Work Order ID 154580

DRAWING NO. D2906	TITLE AH-1 (209) SKIDTUBE ASSEMBLY	REV. B	DART AEROSPACE LTD ENGINEERING ORDER		D.E.O. NO. D2906-B-1	SHEET NO. SHEET 1 OF 1	SCALE NTS
DRAWN A.P.	CHECKED <i>[Signature]</i>	MFG. APPR. <i>[Signature]</i>	APPROVED <i>[Signature]</i>		DE APPR. <i>[Signature]</i>		
DATE 12.05.28	DATE 12.05.28	DATE 12.05.31	DATE 12.05.31		DATE 12.05.31

PURPOSE:

CHANGE ALL C'BORED WELDED CROSSBOLT SPACERS TO SWAGED SPACERS

SECTION C-C A2-2
NOT TO SCALE A2-3

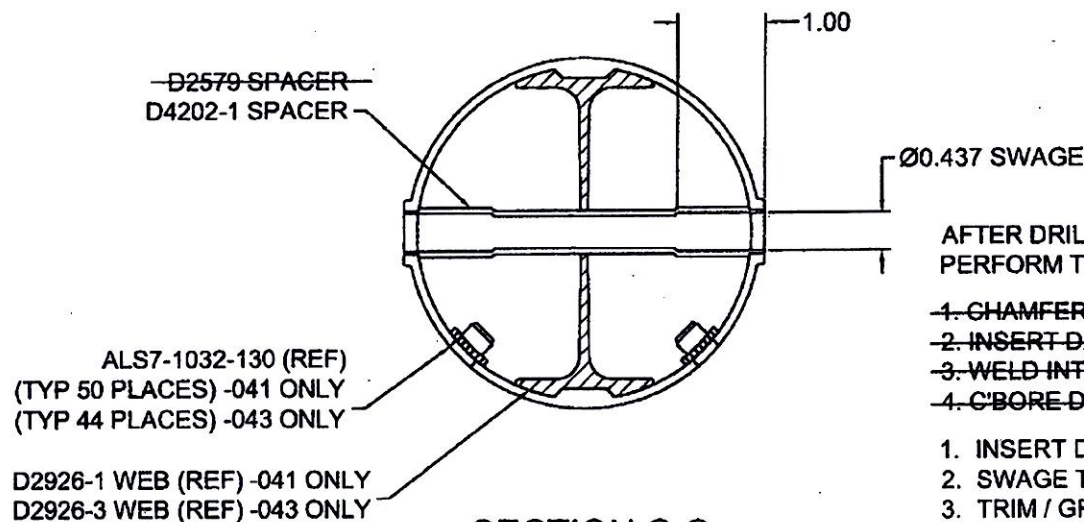
SECTION C-C ON SHEETS 2 & 3 ARE AMENDED AS FOLLOWS FOR ALL HOLES THAT WERE ORIGINALLY C'BORED:

- ~~1. CHAMFER HOLE 0.050 X 45°~~
- ~~2. INSERT D2579 SPACER (20 PLACES)~~
- ~~3. WELD INTO PLACE AND GRIND FLUSH~~
- ~~4. C'BORE D2579 SPACER TO Ø0.437 X 1.00 DEEP~~

1. INSERT D4202-1 SPACER, 22 PL (-041) OR 19 PL (-043)
2. SWAGE TO Ø0.437 X 1.00 DEEP PER QSI 002
3. TRIM / GRIND FLUSH PER QSI 002
